1959 - 1961 Corvette: Service News: Fuel Injection Change

Subject: Fuel Injection Change

Model and Year: 1959 - 1961 Corvette

Date: July, 1961 - Volume 33 - Number 7

Fig. 2—Fuel Injection Cold Enrichment

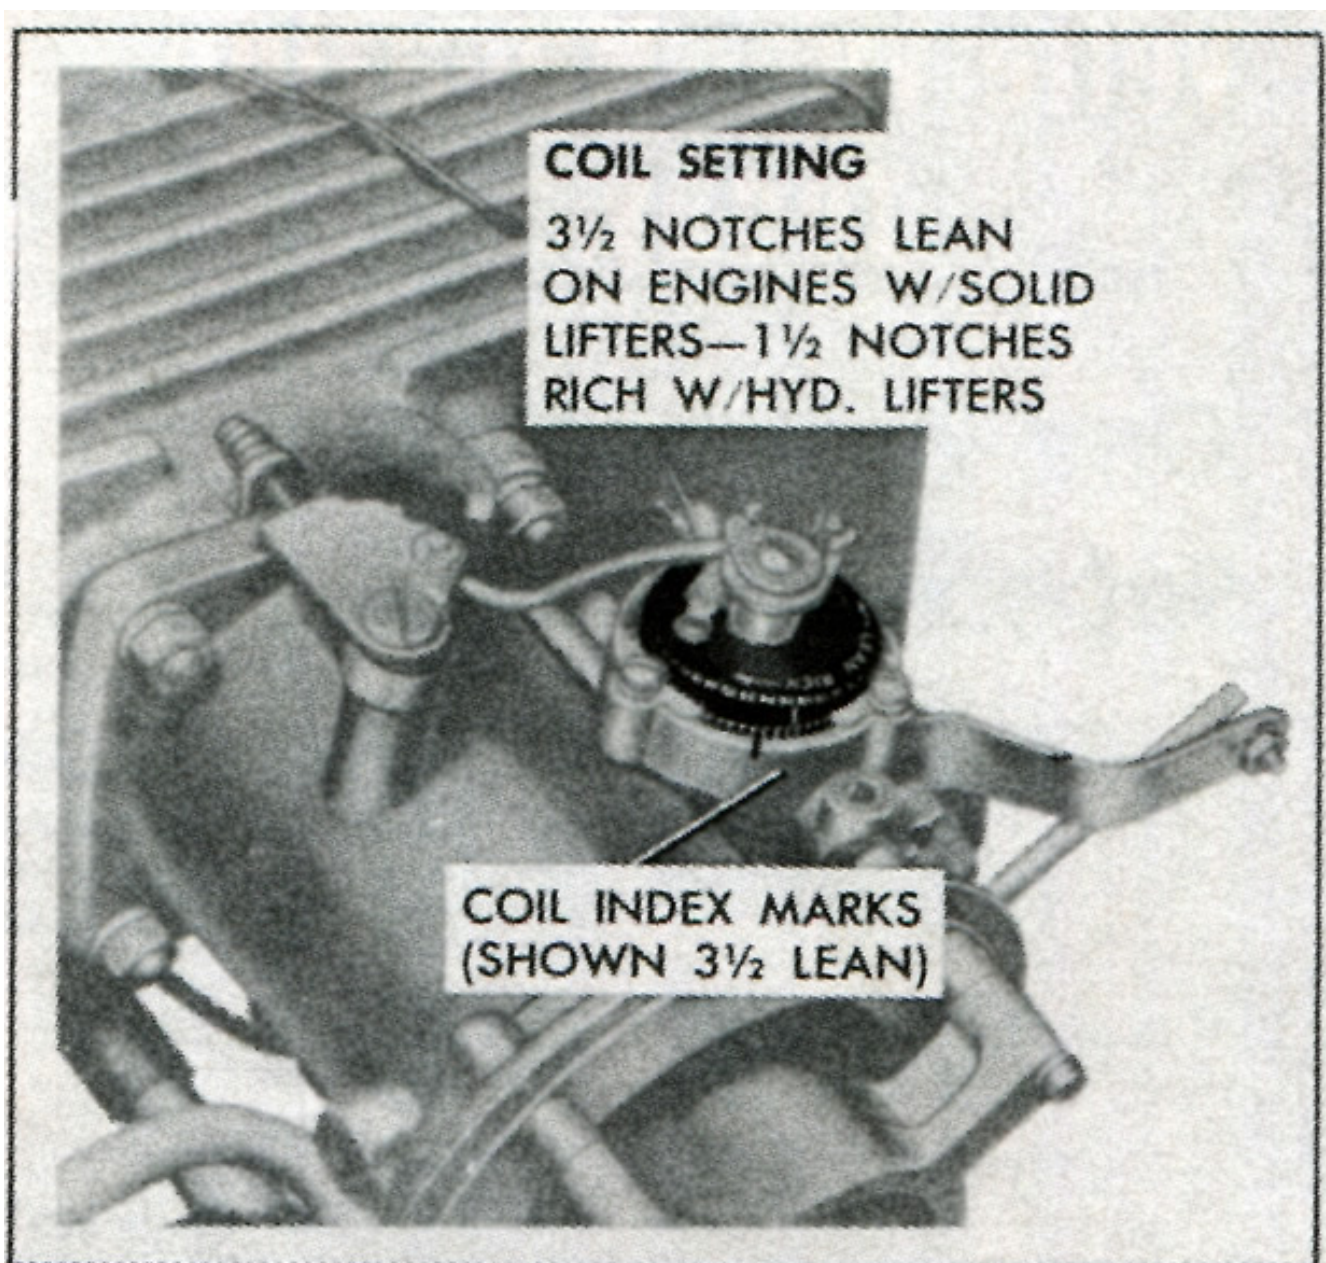
On 290 hp Corvette engines used in 1959 and 315 hp used in 1960 - 1961, the cover setting of the fuel injection thermostatic coil, that provides cold engine fuel enrichment, should be adjusted to 3 1/2 notches lean from the index mark on the cold enrichment housing (Fig. 2). The cold enrichment coil setting of 1 1/2 notches rich will still be used on all fuel injection engines of lower horsepower.
